UNITED STATES PATENT AND TRADEMARK OFFICE

Office Action Summary

09/236,373

BUHLER, BRUCE A.

FIGURE 5

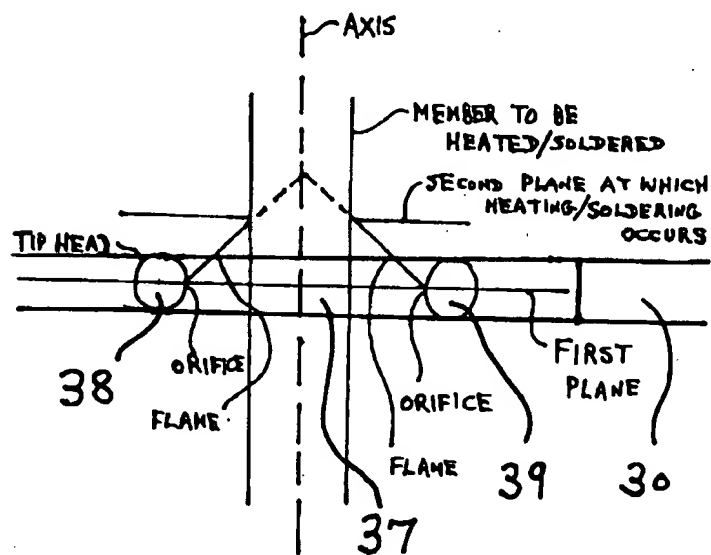
The amendment filed 09/24/2007 is objected to under 35 U.S.C. 132(a) because it introduces new matter into the disclosure. 35 U.S.C. 132(a) states that no amendment shall introduce new matter into the disclosure of the invention. The added material which is not supported by the original disclosure is as follows: There is no support in the original disclosure for the manner in which the various elements of the newly submitted drawing figure 2 are illustrated.

The drawings are objected to under 37 CFR 1.83(a). The drawings must show every feature of the invention specified in the claims. Therefore, the ports being angularly oriented to generate flames extending from first to a second plane, etc. and the flames projecting outwardly with respect to the first plane to achieve heating along the second plane (see, for example, the last paragraph of claim 1 (amended)) must be shown or the feature(s) canceled from the claim(s). These structural details are essential for a proper understanding of the disclosed invention since applicant has amended the claims to include these limitations in an attempt to distinguish the claimed invention over the prior art of record. No new matter should be entered.

NOT
ACCEPTED
NOT
APPROVED
9/27/07

Applicant is required to cancel the new matter in the reply to this Office Action.

Corrected drawing sheets in compliance with 37 CFR 1.121(d) are required in reply to the Office action to avoid abandonment of the application. Any amended replacement drawing sheet should include all of the figures appearing on the immediate prior version of the sheet, even if only one figure is being amended. The figure or figure number of an amended drawing should not be labeled as "amended." If a drawing figure is to be canceled, the appropriate figure must be removed from the replacement sheet, and where necessary, the remaining figures must be renumbered and appropriate changes made to the brief description of the several views of the drawings for consistency. Additional replacement sheets may be necessary to show the renumbering of the remaining figures. Each drawing sheet submitted after the filing date of an application must be labeled in the top margin as either "Replacement Sheet" or "New Sheet" pursuant to 37 CFR 1.121(d). If the changes are not accepted by the examiner, the applicant will be notified and informed of any required corrective action in the next Office action. The objection to the drawings will not be held in abeyance.
